**CITY OF BELMONT
PLEASANTS COUNTY, WEST VIRGINIA**

CONTRACT #2 – WATER TREATMENT PLANT UPGRADES

ADDENDUM #2

THRASHER PROJECT #T10-11028

EXISTING FILTER BUILDING - IMPROVEMENT PLAN
 SCALE 1/4" = 1'-0"

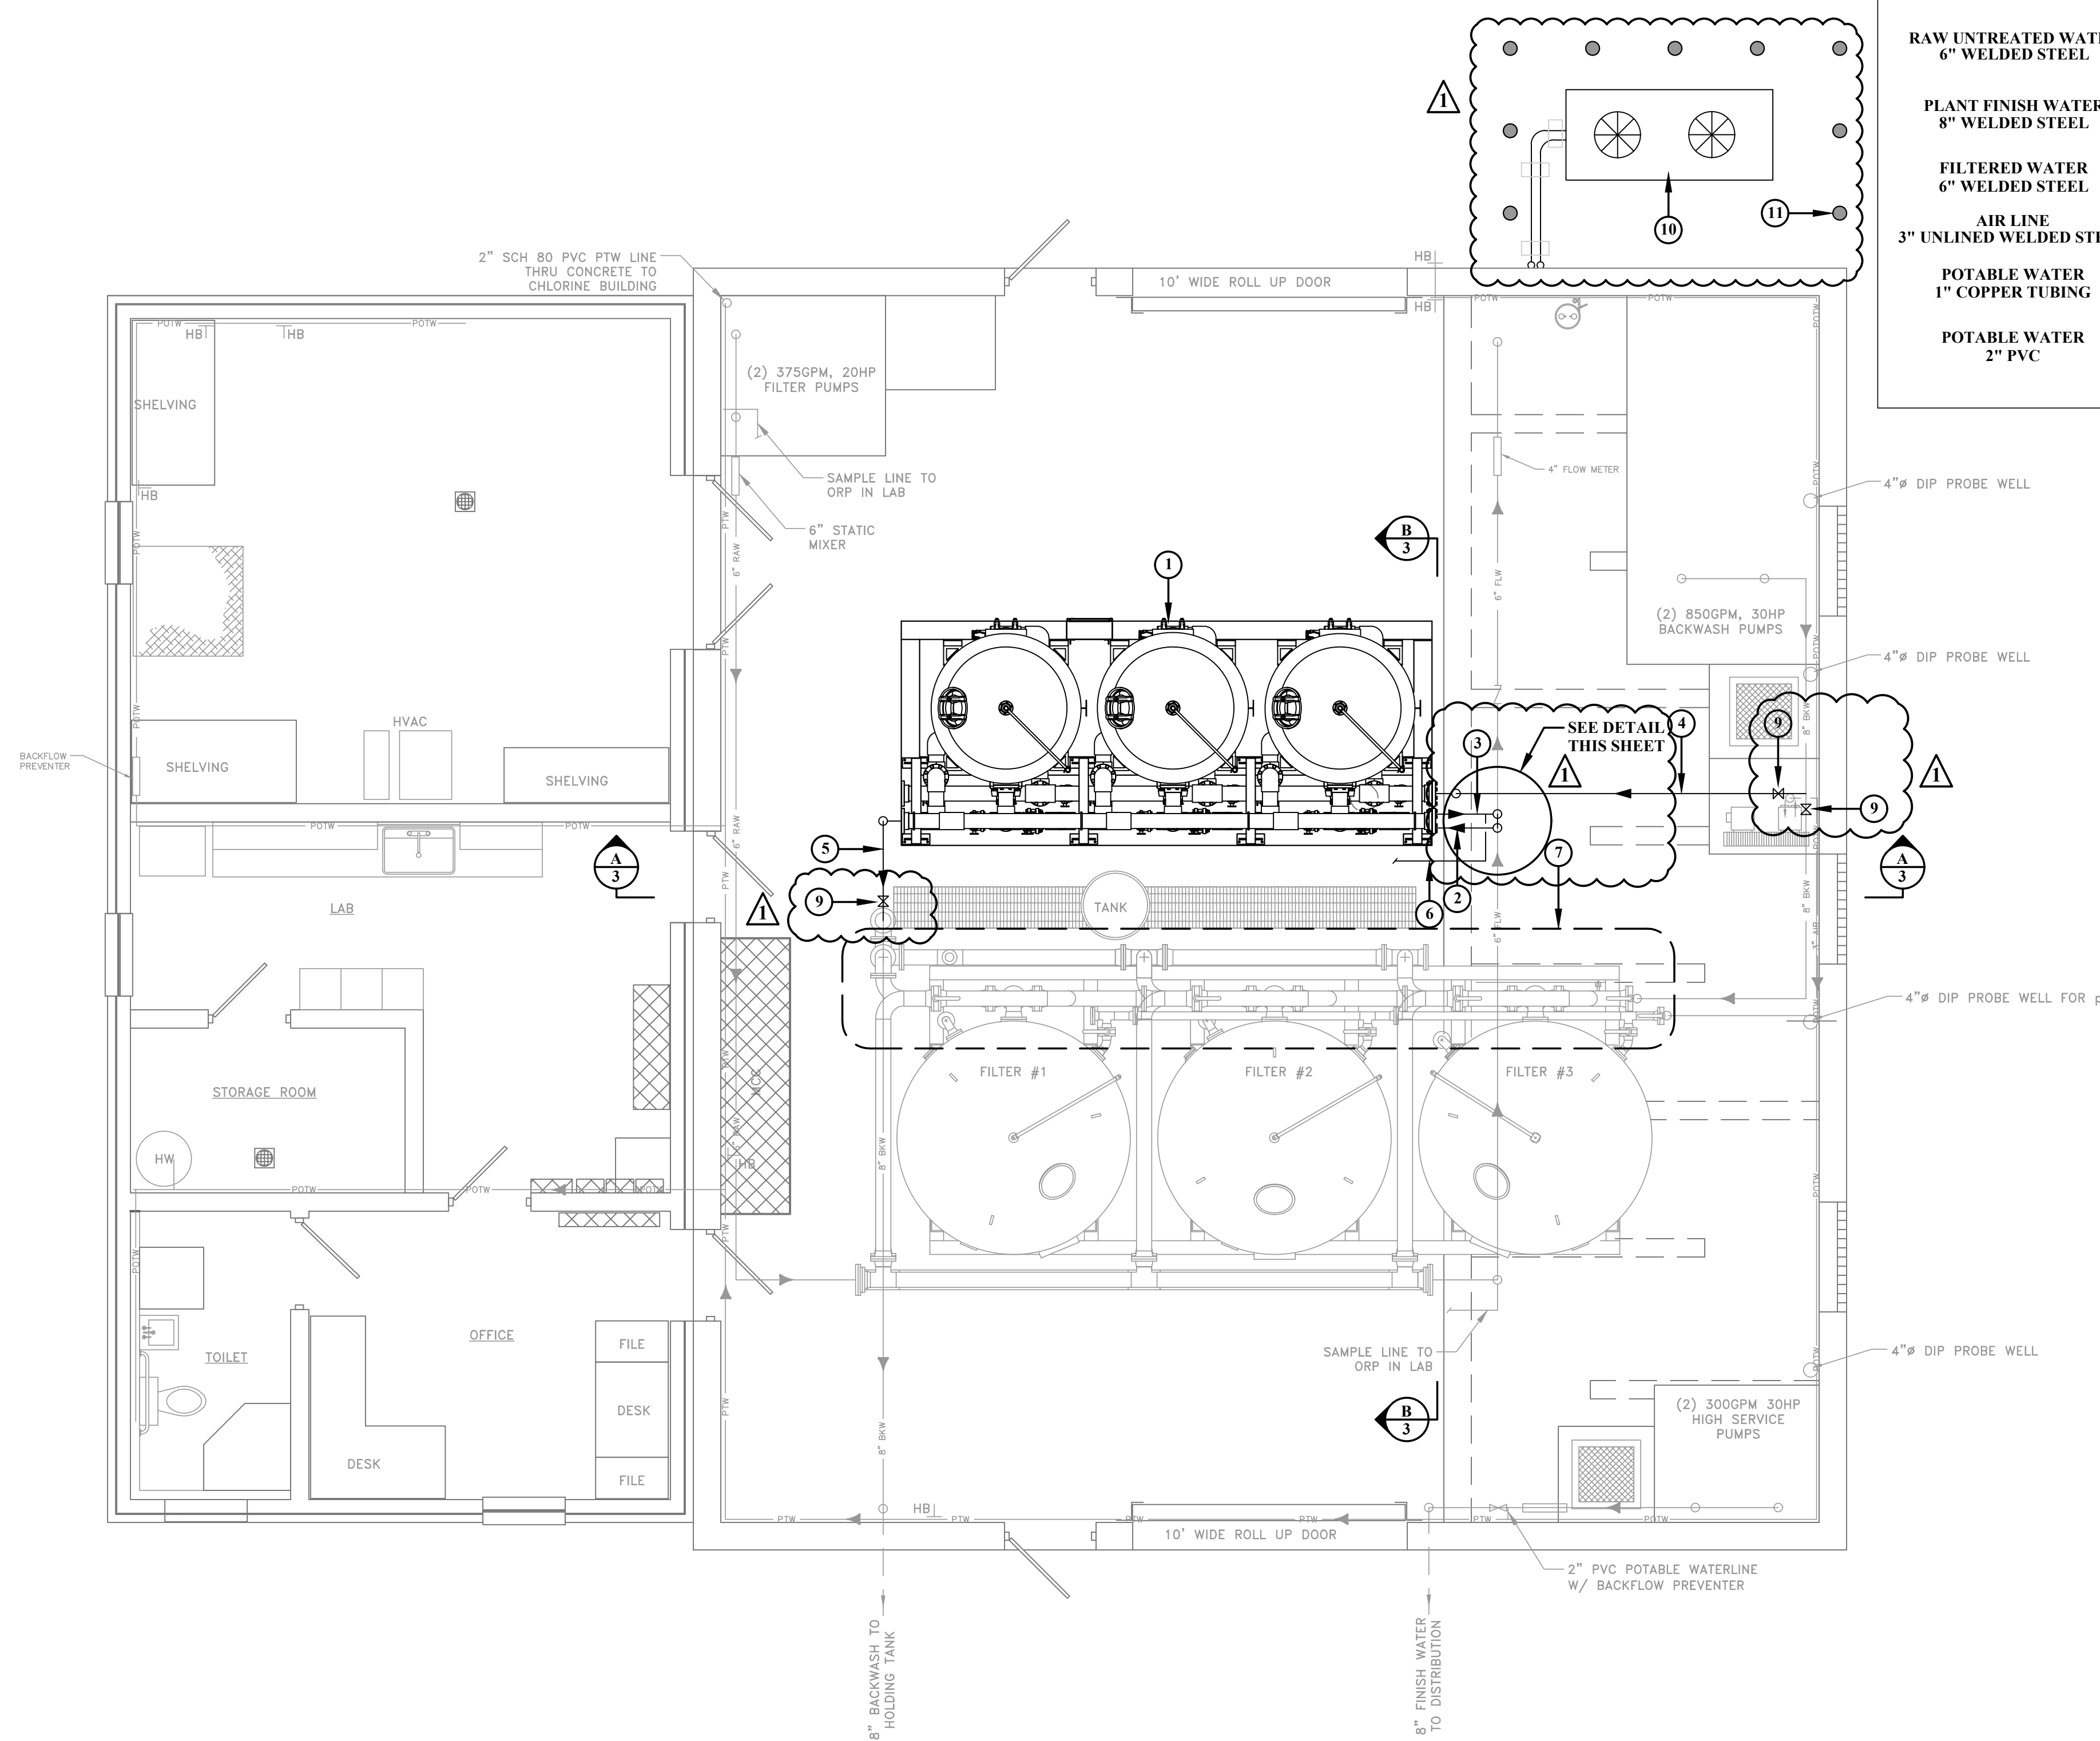
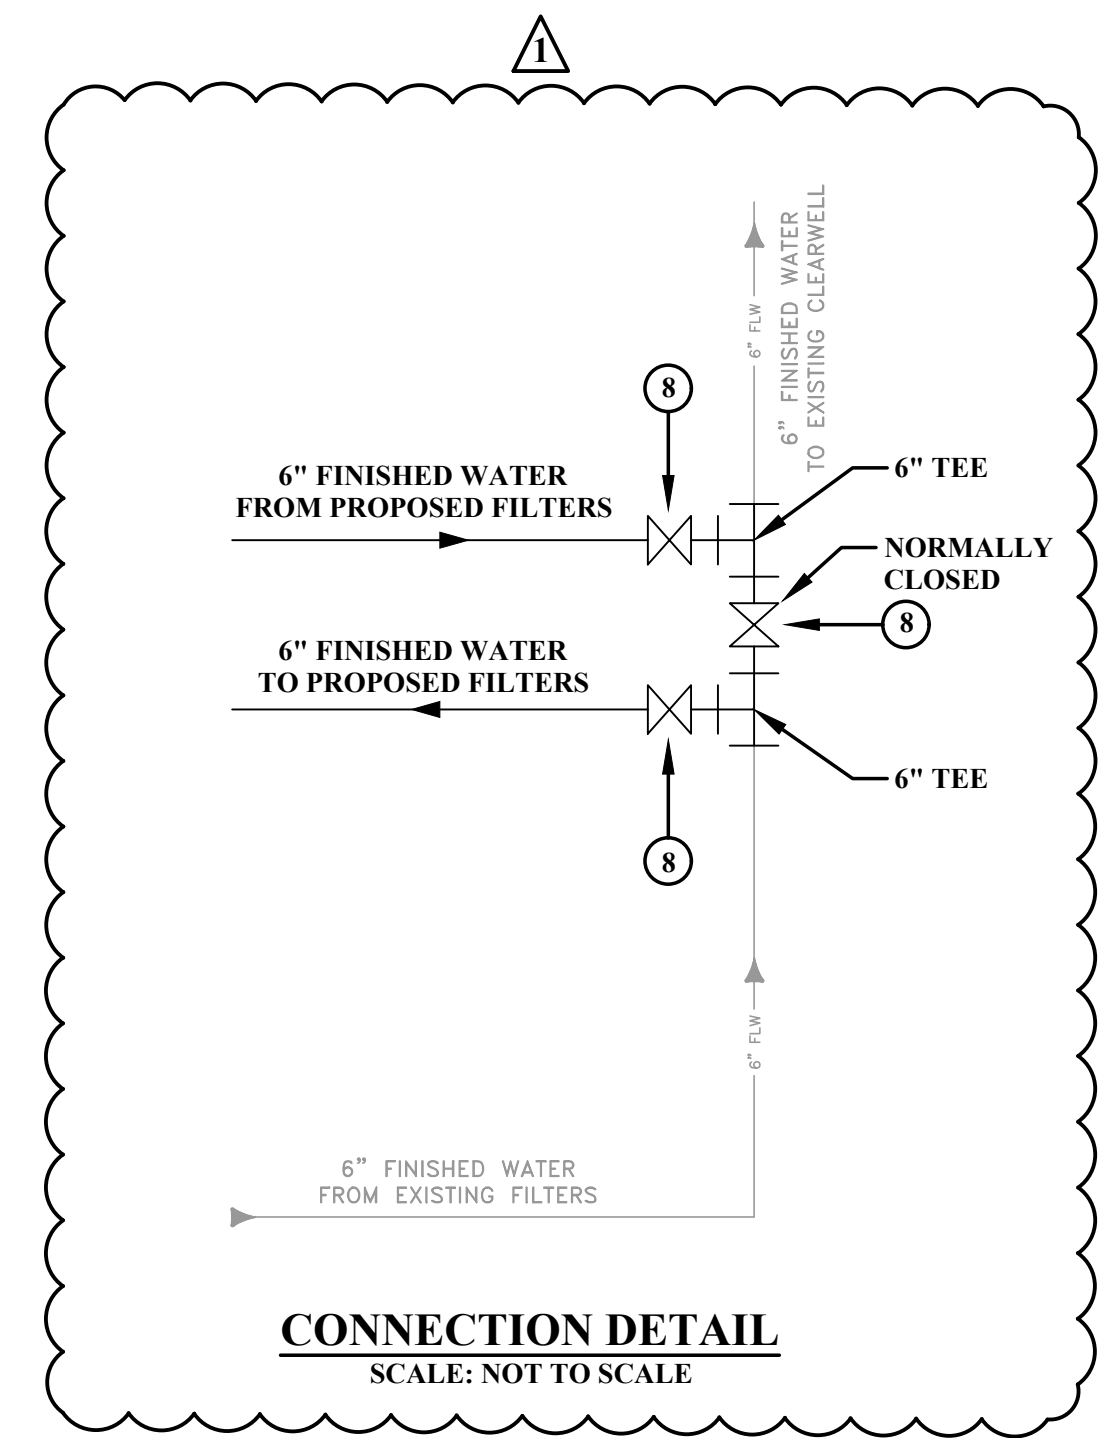
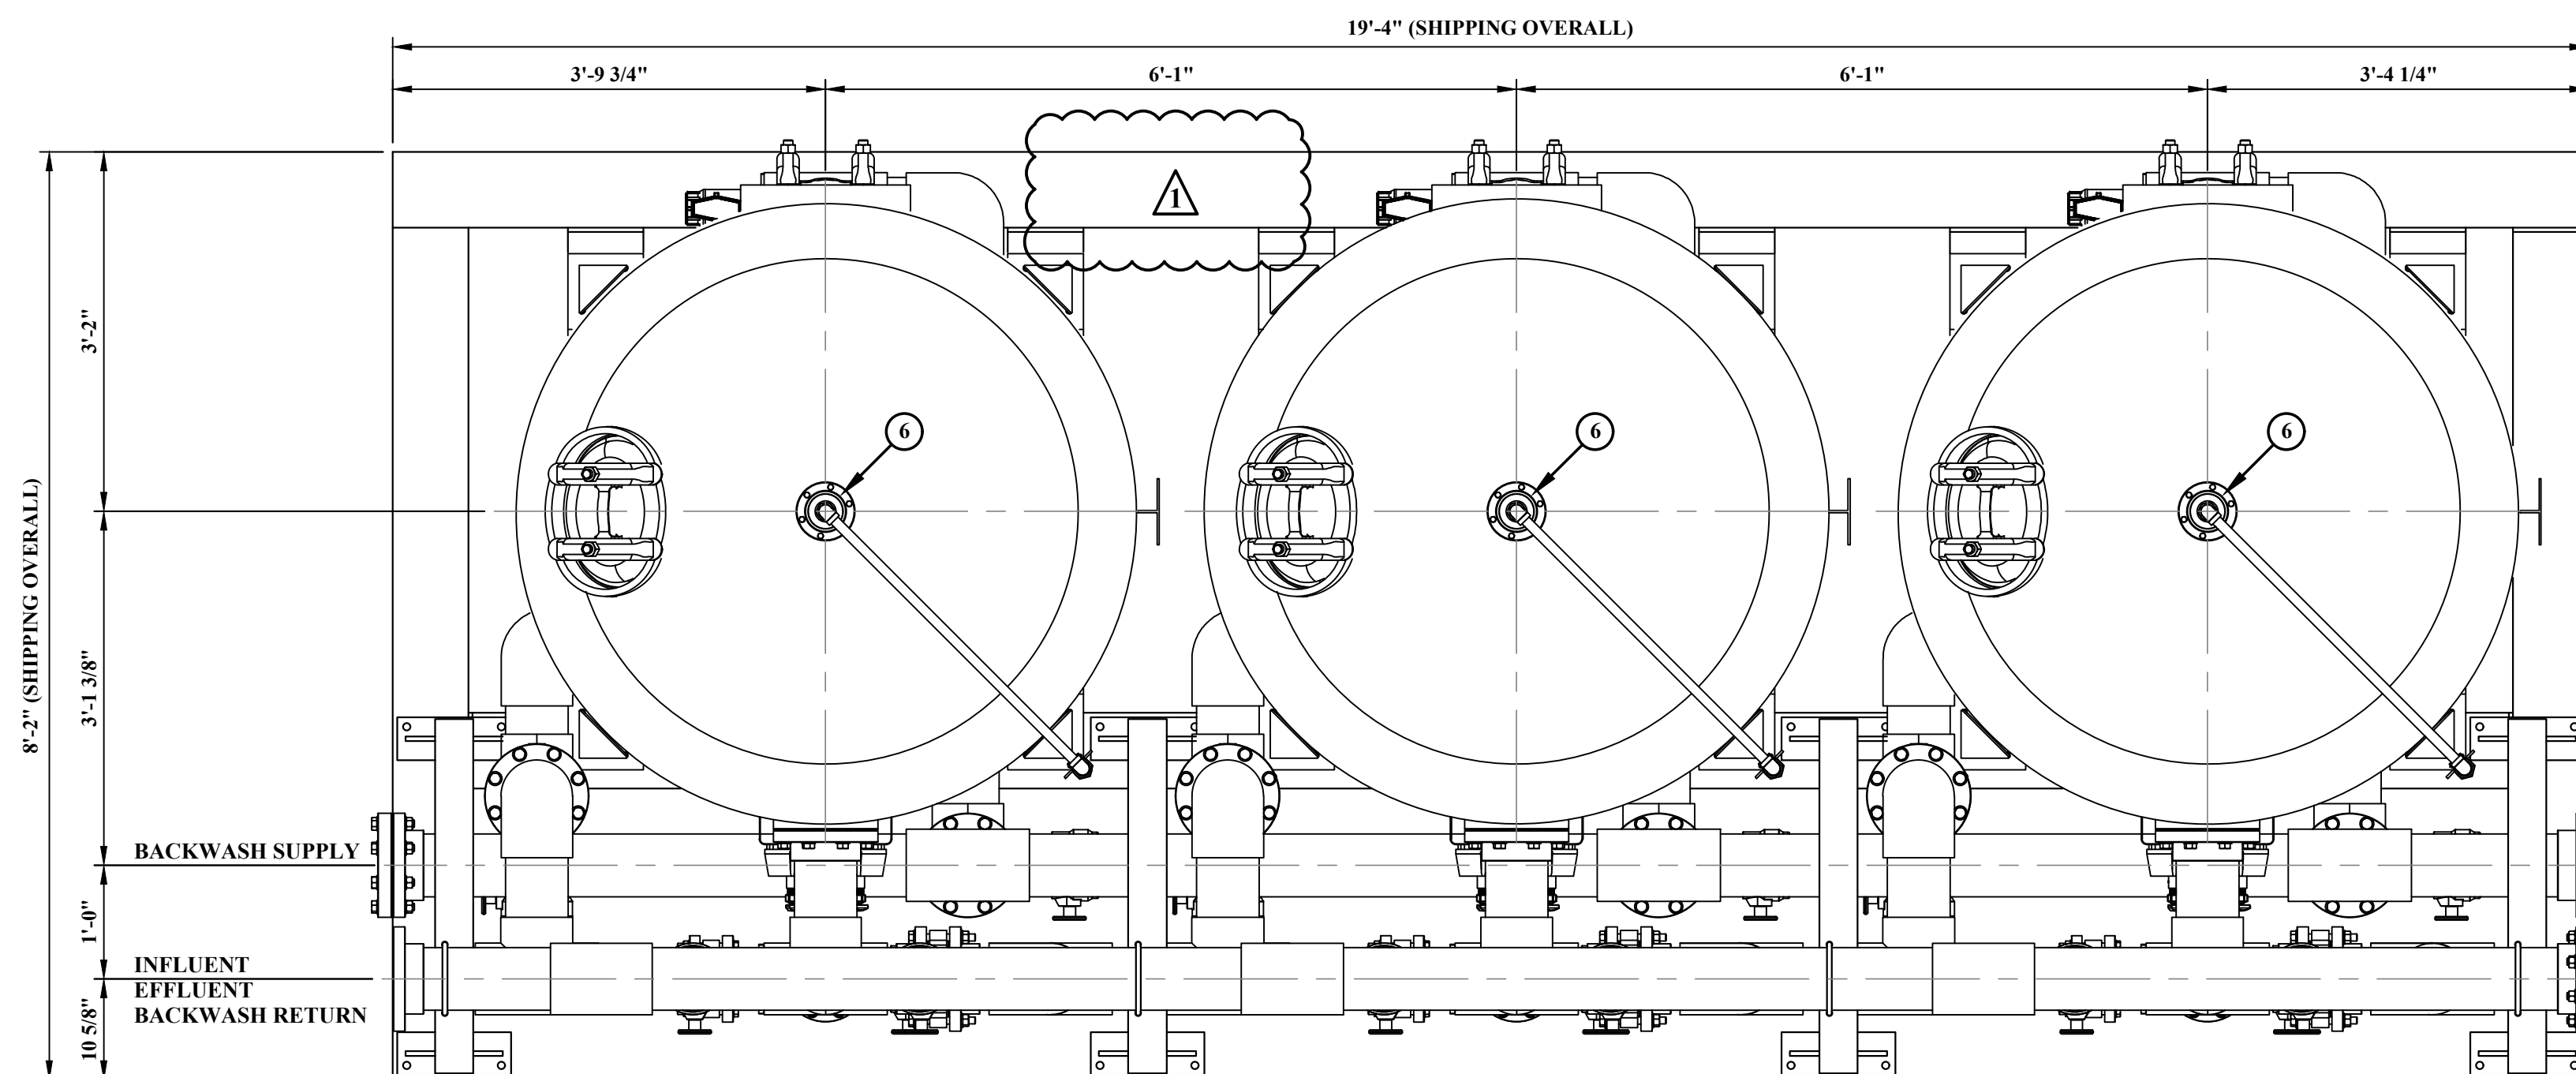
NO.	BY	DATE	DESCRIPTION
1	ISF	7/30/24	ADDENDUM #2 - ADDED NOTES 8-11 & CONNECTION DETAIL
